Memorandum

From: Matt Abernathy, Senior Forest Health Program Specialist – Resource Conservation District of Santa Cruz County

Subject: Minor Clarification to the Skylark Ranch Forest Health Project PSA

Figure 1: Map depicting the additional acreage by CalVTP type over hillshade base map.

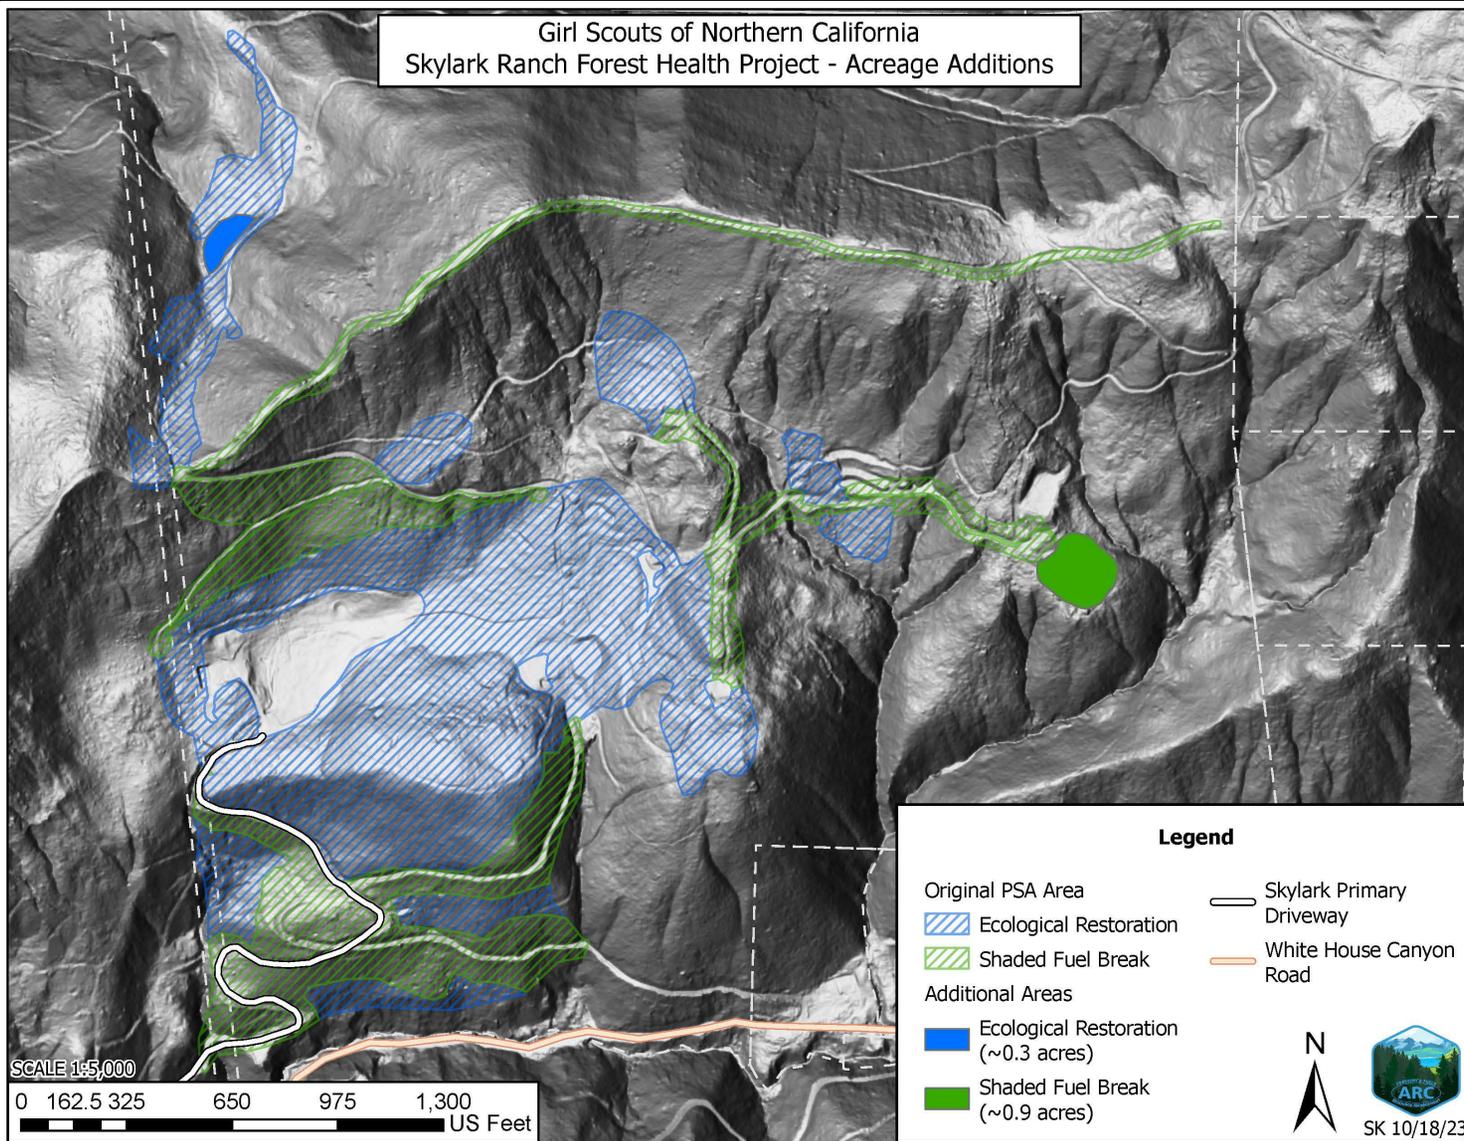
The project description in the PSA describes the analysis that was conducted to generate the project's treatment areas. As described in Chapter 1.4. "Project Justification" of the PSA, "The Skylark Ranch treatment area development phase began by analyzing where sensitive resource areas were located (e.g., watercourses, steep slopes, sensitive vegetation communities/species, etc.). These types of resources were mapped and specific areas with increased feasibility and efficacy of treatment (e.g., less steep slopes, ridges, and areas away from watercourses, etc.) were field verified for access, to evaluate the level of impaired forest condition, and to consider treatment options." The initial mapping analyzed the slopes on the Skylark Ranch and had identified the mechanically operable slopes (slopes less than 50%) and high use areas where additional manual work should occur on slopes than 60%. Through further field investigation, it has been found that an additional 1.8 acres are mechanically operable, as they are less than 35% in slope. Including these additional 1.8 acres would promote better connectivity of treatment areas, making it easier to operate and resulting in fewer ground disturbing activities, and will increase the effectiveness of treatment. The inclusion of these 1.8 acres is in line with the original intent of this project to be "both cost-effective and to avoid and minimize resource impacts", as it will be both more time efficient for the heavy equipment operator to work progressively through the area, and it will result in less disturbance as the heavy equipment operator would no longer need to back out to avoid the erroneously omitted ground,

The current condition of the additional acreage identified during field investigations is the same as the treatment area already identified in the PSA. Omission of the 1.8 acres is likely due to the imprecision of available slope data; had more precise data been available, the RCD would have included this acreage in the PSA initially. The analysis in the PSA considered the potential impacts of using mechanical equipment and operating on steep slopes with the

Attachment 2: Figure 1 – Map depicting the additional acreage by CalVTP type over hillshade base map.

Figure 2: Map depicting the total acreage by CalVTP type over aerial imagery.

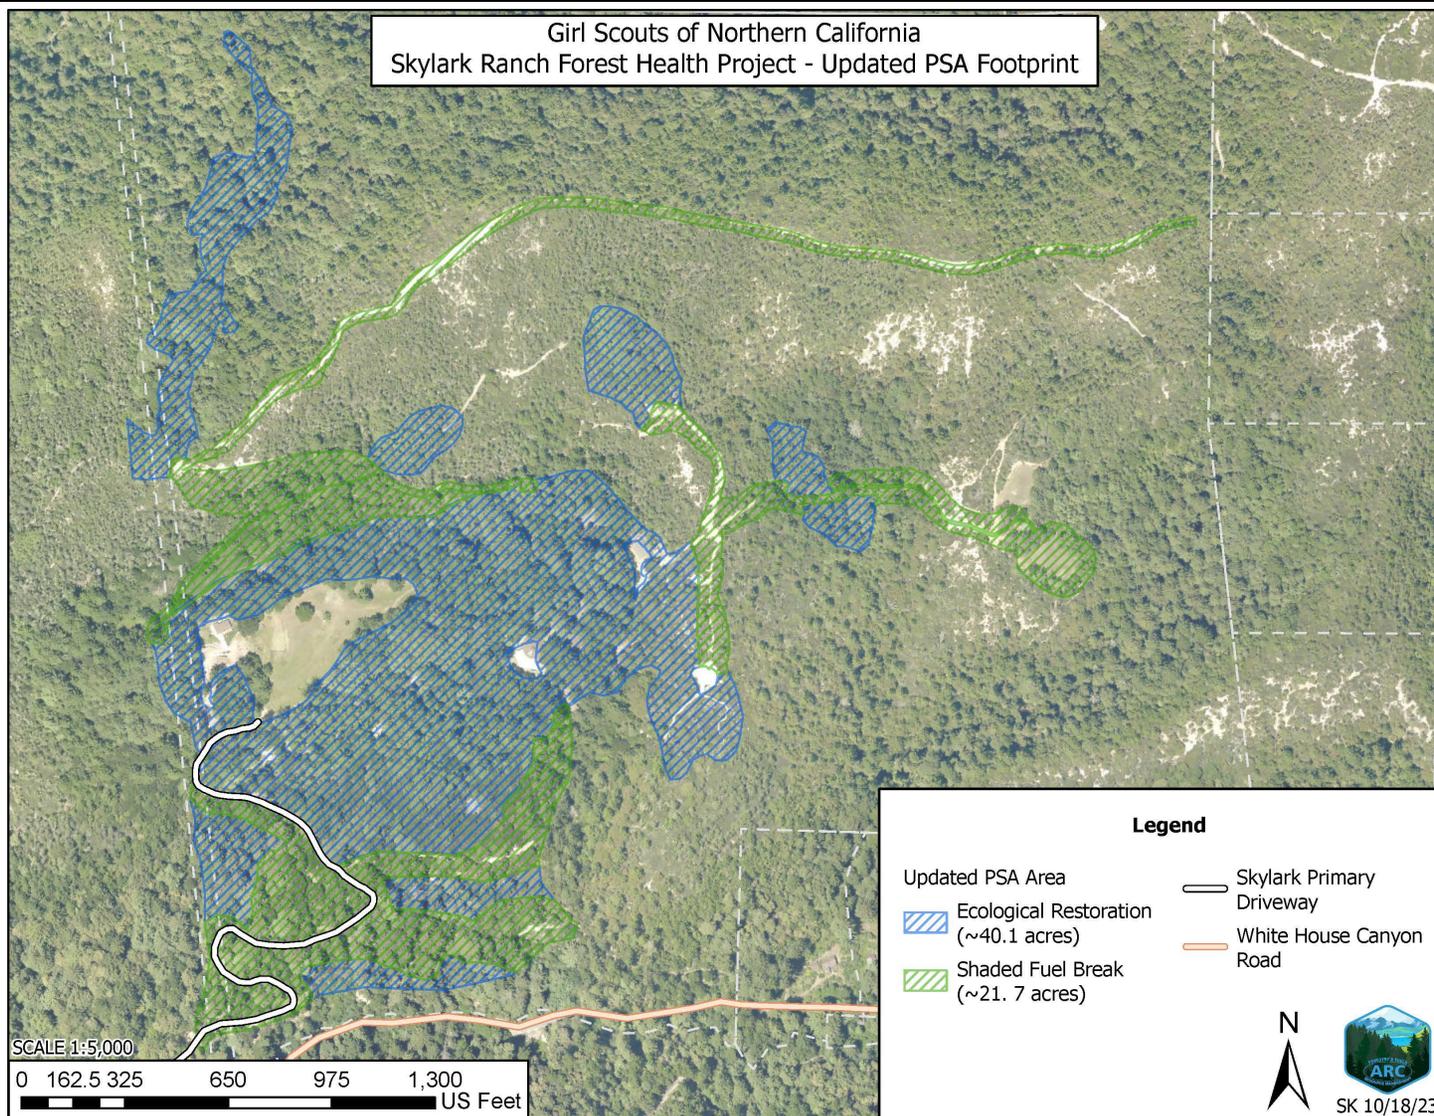
Attachment 3: Figure – Map depicting the total acreage by CalVTP type over aerial imagery.
